**7-SB-21-C
CONCEPT PLAN**

Subdivision: Capital Drive

Approval of Concept Plan

**CAPITAL DRIVE-KINGSTON PIKE
RETAIL DEVELOPMENT
KNOX COUNTY, TENNESSEE
TRANSPORTATION IMPACT ANALYSIS**

7-SB-21-C
Revised: 8/5/2021

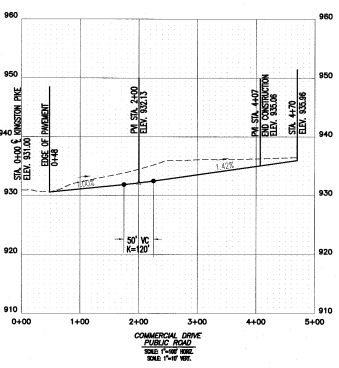
1. Revising the sidewalk design to meet requirements of Knox County Engineering and Public Works, City of Knoxville Department of Engineering, and/or Tennessee Department of Transportation.

3. Modifying the existing stormwater ponds on lots 1 & 4 to meet the Knox County Stormwater Management Ordinance.
4. Installing notification of future street connection at the north end of Commercial Drive as required by Section 3.04.C.2.d. of the Knoxville-Knox County Subdivision Regulations.

6. Provision of street names that are consistent with the Uniform Street Naming and Addressing System within Knox County (Ord 91-1-102).
7. Placing a note on the final plat that all lots will have access only to the internal street system.

The City of Knoxville requires sidewalks to be installed along road frontages when a property is developed or redeveloped, so a sidewalk along the Kingston Pike frontage is required. The existing detention ponds on lots 1 and 4 will be modified with the installation of the new road, however, the concept plan does not show a preliminary design for these modifications. The primary concern is how the pond on Lot 4 will impact the parking lot design for the existing business and the applicant has indicated the detention pond will be moved underground.

Figure 9

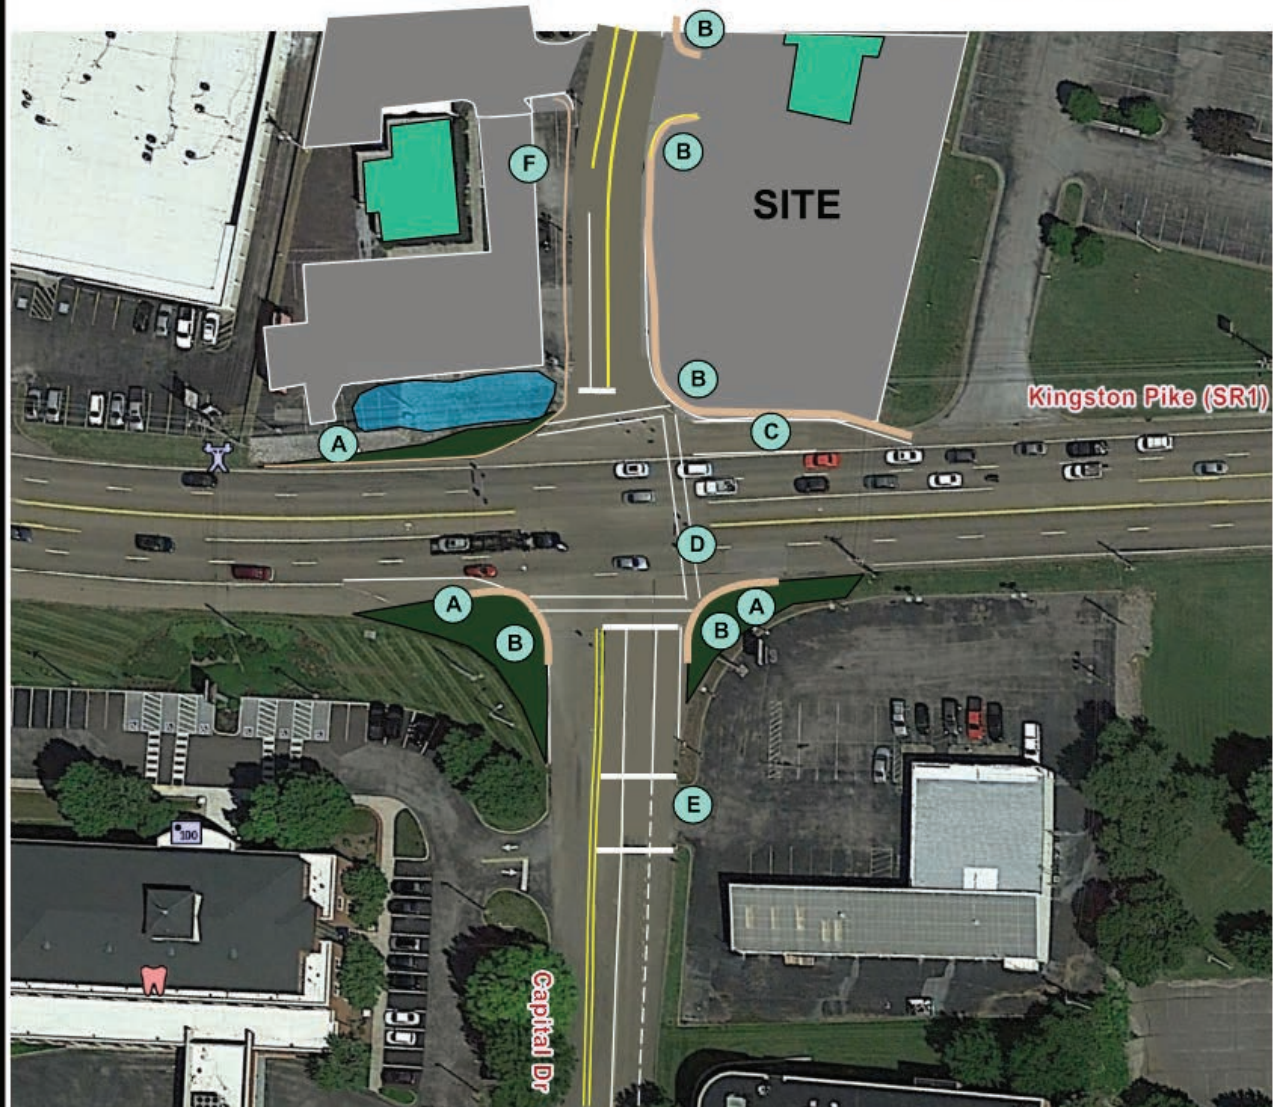
- Provide 100-foot storage for a left-turn lane on the new connector stub road at the southbound approach to Kingston Pike as shown in **Figure 9**.
 - o Ensure there are no driveway openings to the GemStore and proposed retail developments within this storage length.

- Reconfigure the northbound approach on Capital Drive to provide a 300-foot storage left-turn lane, a separate through lane, and a separate right-turn lane as shown in **Figure 9**.

- Provide a 50-foot storage westbound right-turn lane on Kingston Pike via appropriate striping as shown in **Figure 9**.
- City of Knoxville staff have indicated that sidewalks will likely be required both internally along the new connector stub of Capital Drive and along the Kingston Pike road frontage. This will require the construction of sidewalk and ADA-compliant curb ramps along the proposed Kingston Pike westbound right-turn lane to Capital Drive, around the radii of the new connector stub road, and any connecting corners of the study intersection.

- Provide crosswalk striping from the northwest to northeast to southeast corners of the study intersection as shown in **Figure 9**.
- Post STOP signs (R1-1) for exiting traffic from the GemStore, proposed coffee/donut shop, and proposed retail strip development driveways located along the new connector road north of Kingston Pike.
